ADDENDUM NO.: 3
 DATE OF CMR ADDENDUM: 1/24/2014

Project Name:	Renovations and Additions to Emmett O'Brien Technical High School
Project Location:	141 Prindle Avenue, Ansonia, Connecticut
CT DCS Project Number:	BI-RT-844-CMR

ADDENDUM NO. 3

**Renovations and Additions to
Emmett O'Brien Technical High School
141 Prindle Avenue
ANSONIA, CONNECTICUT
Project # BI-RT-844-CM-R**

Reference: Drawing number: S2.O.H Detail: _____ Spec. Section: _____

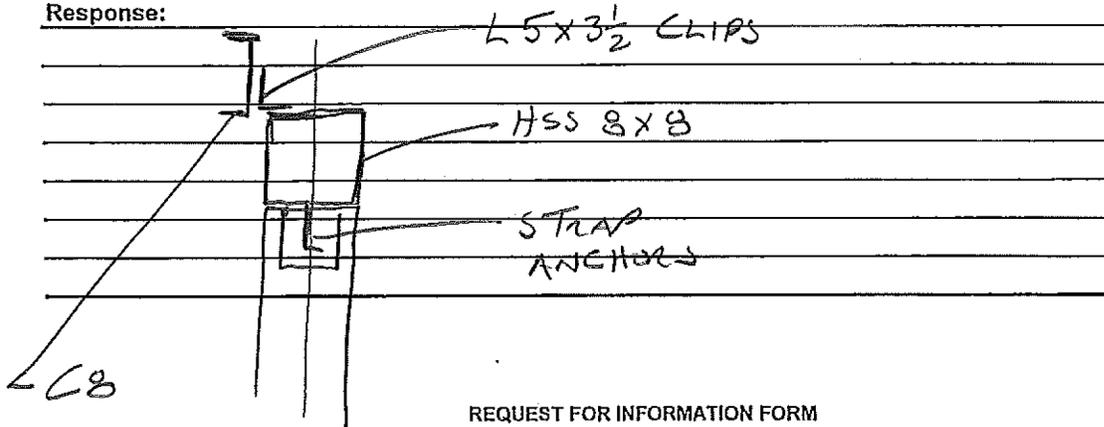
Please provide a section cut of Note 1 on drawing S-2.O.H.

SKA-008

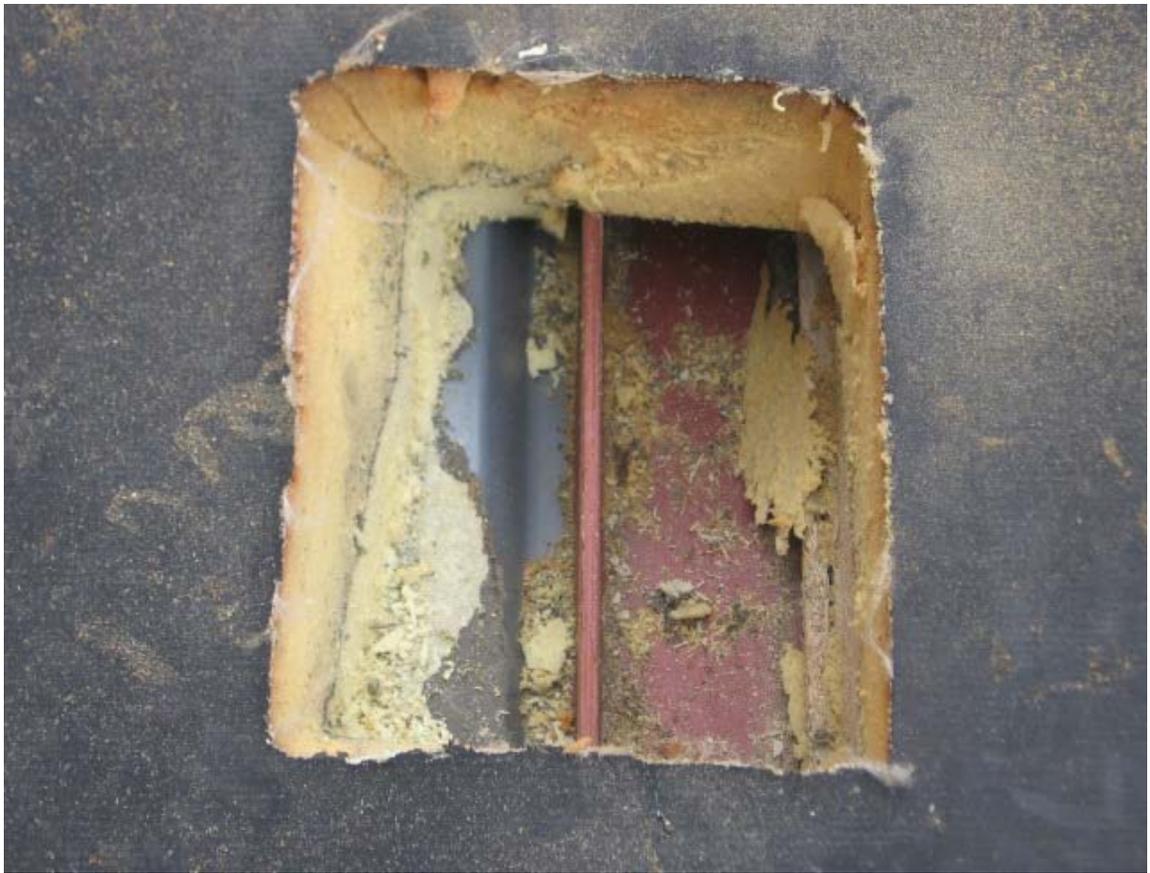
RFI #19
REFERENCE: Drawing number A6.5.6 & A6.6.2 Detail assorted Spec Section 06 65 00
INFORMATION REQUESTED: Both the solid surface sill detail drawings on A6.5.6 and A6.6.2 and the specifications in paragraph 2.2.B on page 3 of section 06 65 00 indicate that the solid surface sills are fabricated from 3/4" thick material. However, the solid surface materials specified are 1/2" thick. Please confirm that 1/2" thick material is acceptable (a thicker substrate can be used to achieve the same finished dimensions).

Response to bidder question #15
This section is cut through a classroom window. Sill information for typical classrooms can be found on drawing 1/A6.5.6
-DRA Architects, 1/23/2014

MODIFICATION OF 2 BOLLARDS LOCATED
 INLOADING AREA TO PROVIDE MIN. SPACE AT DOORS

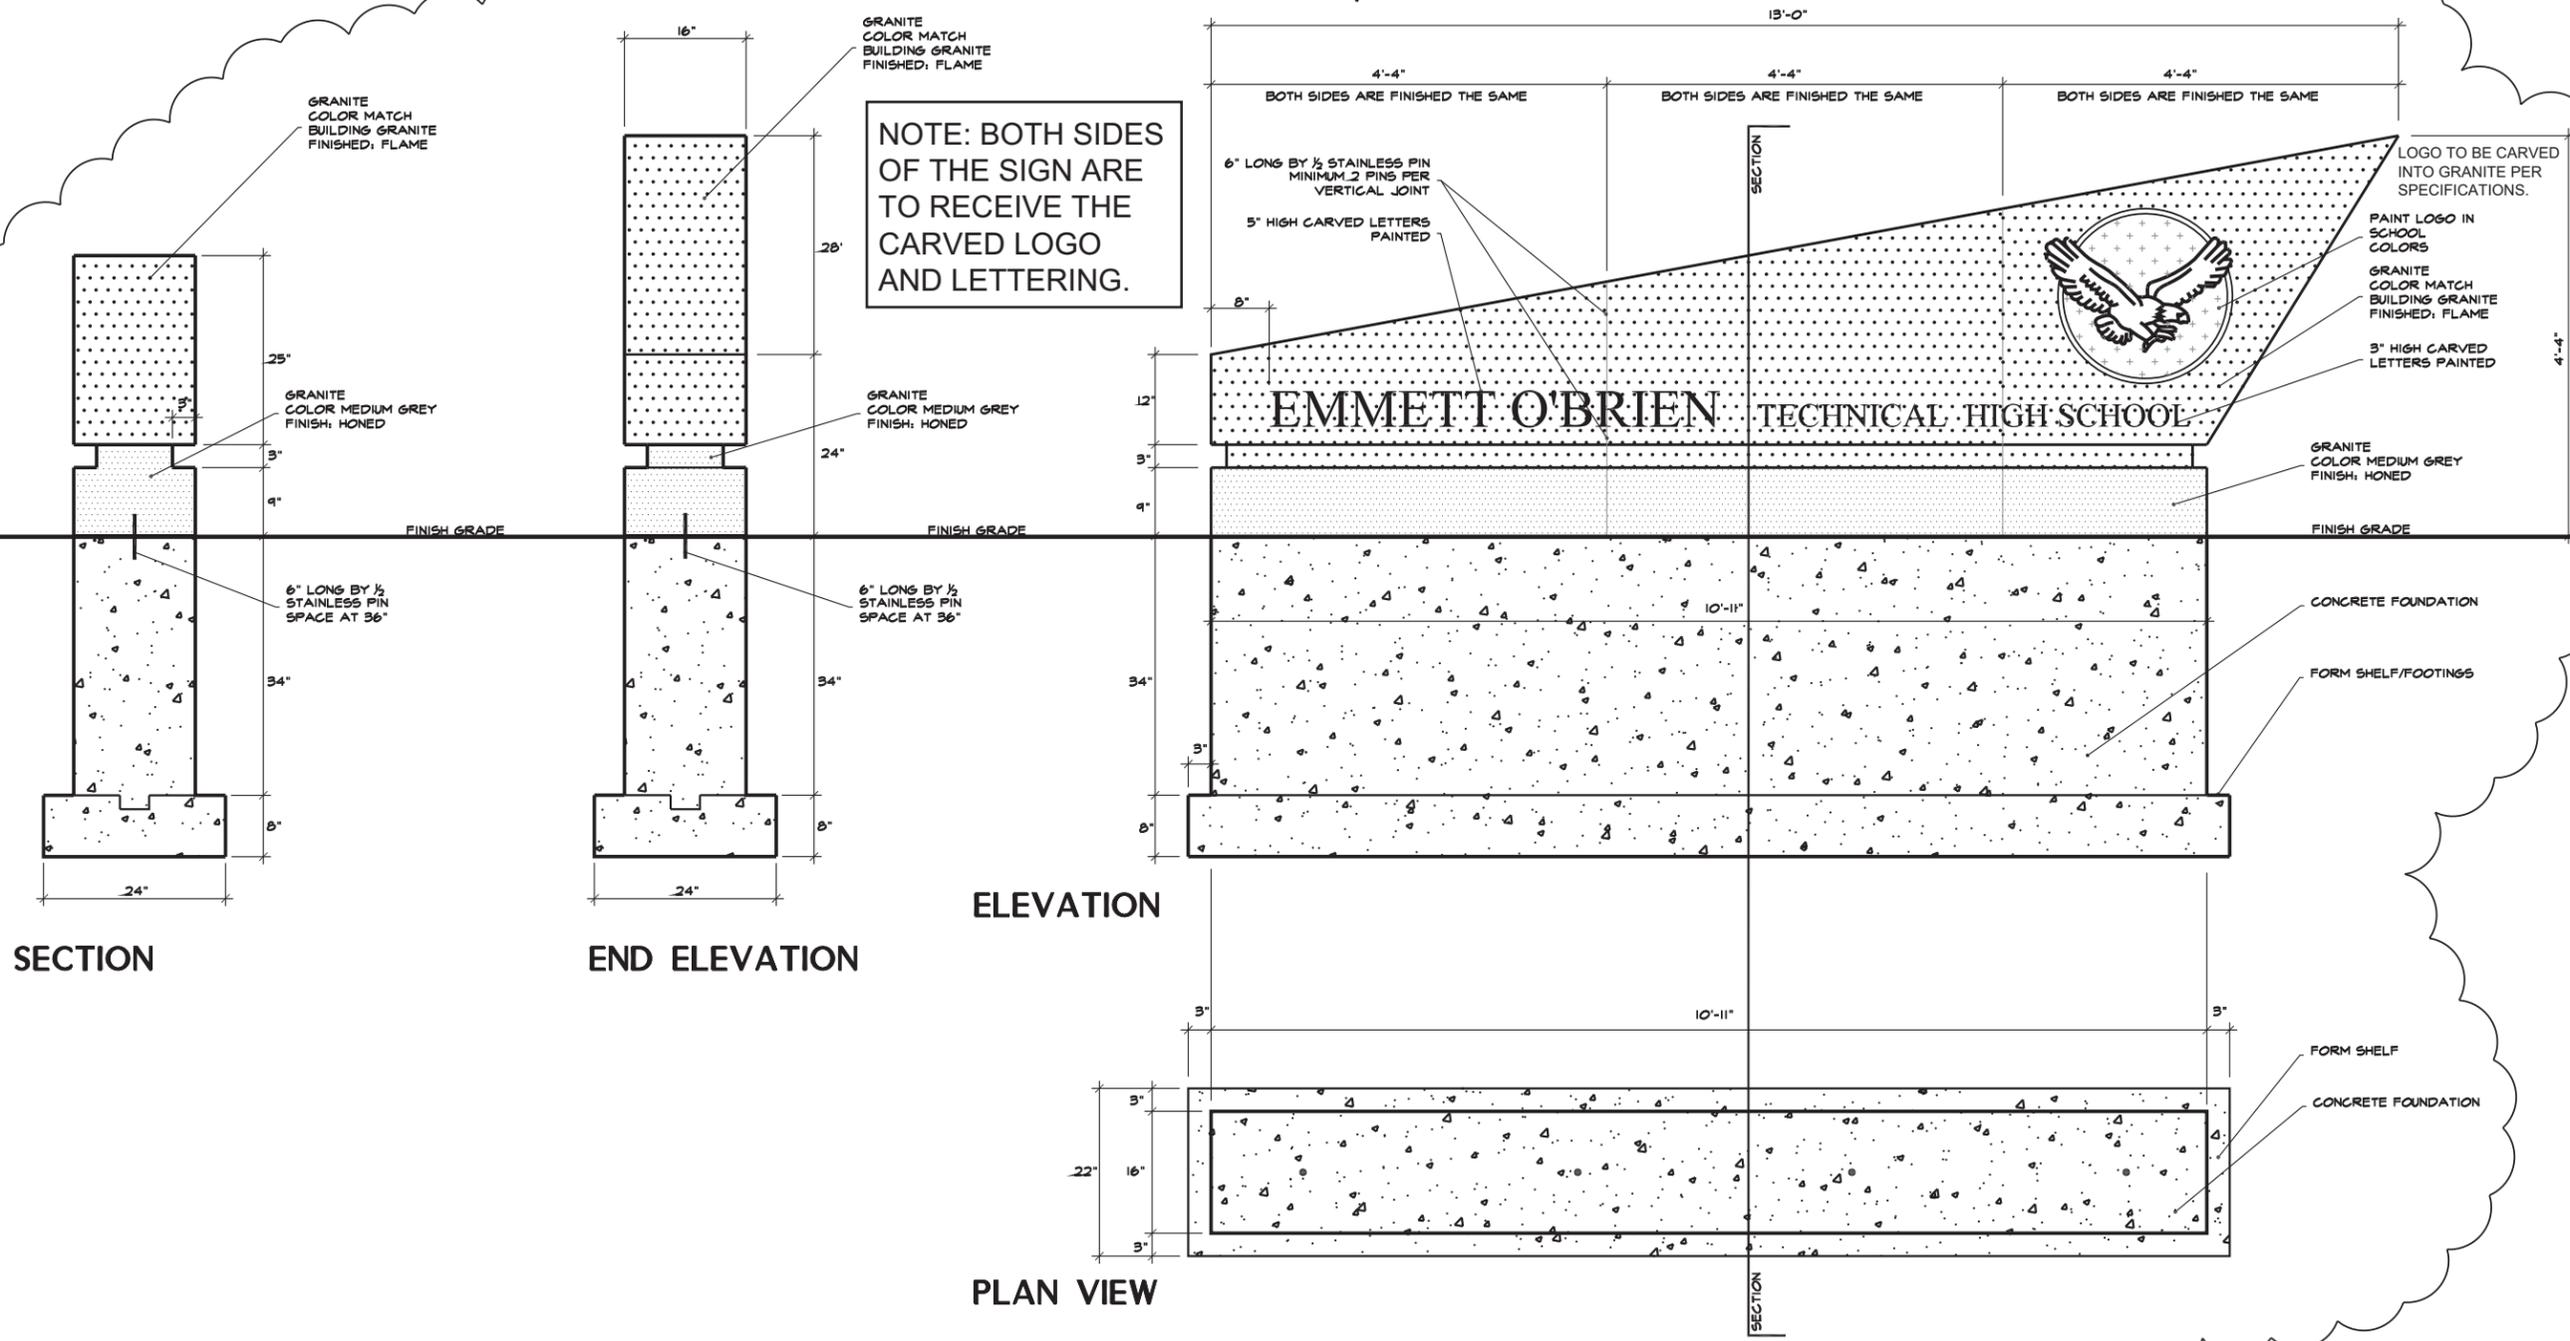
ADD 3-026 L3.1 – SITE LAYOUT ENLARGEMENT

REVISE drawing per attached sketch SKL-001
Create a min. of 6' between the bollards in front of the door.

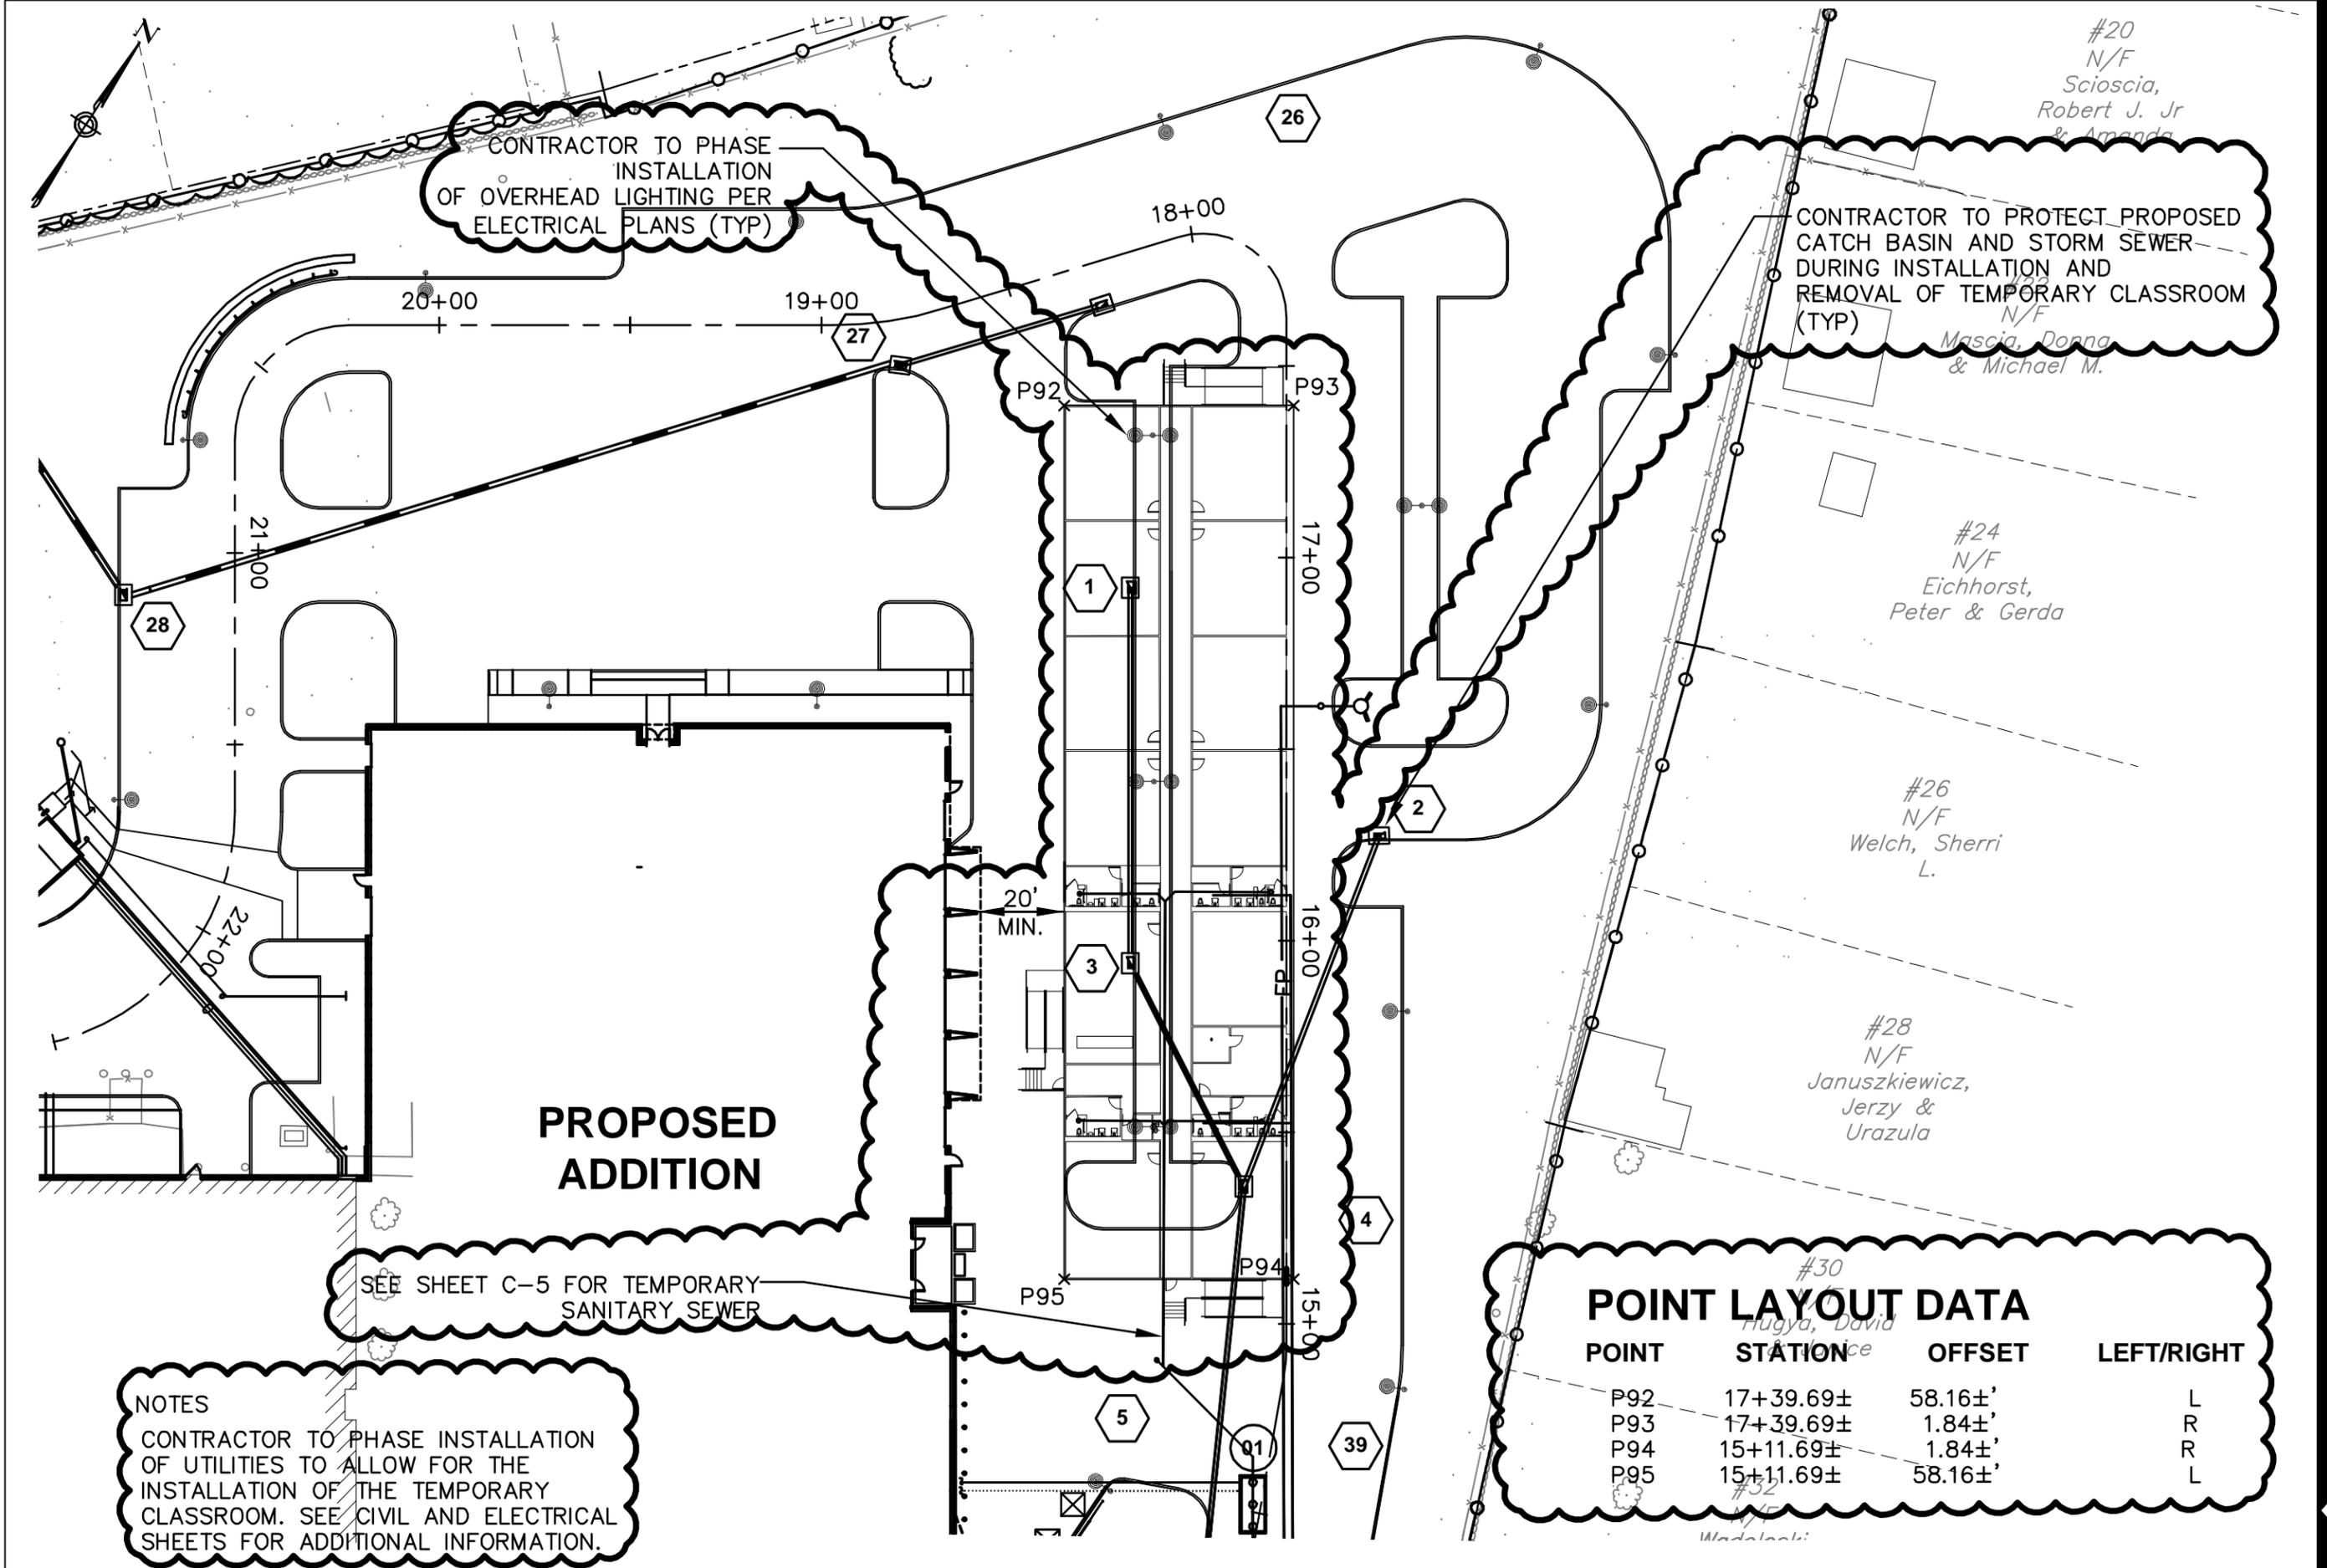
ADD 3-028 L5.11 – SITE METAL SCREENS

ADD Main Entrance Sign per attached sketch SKL-003.
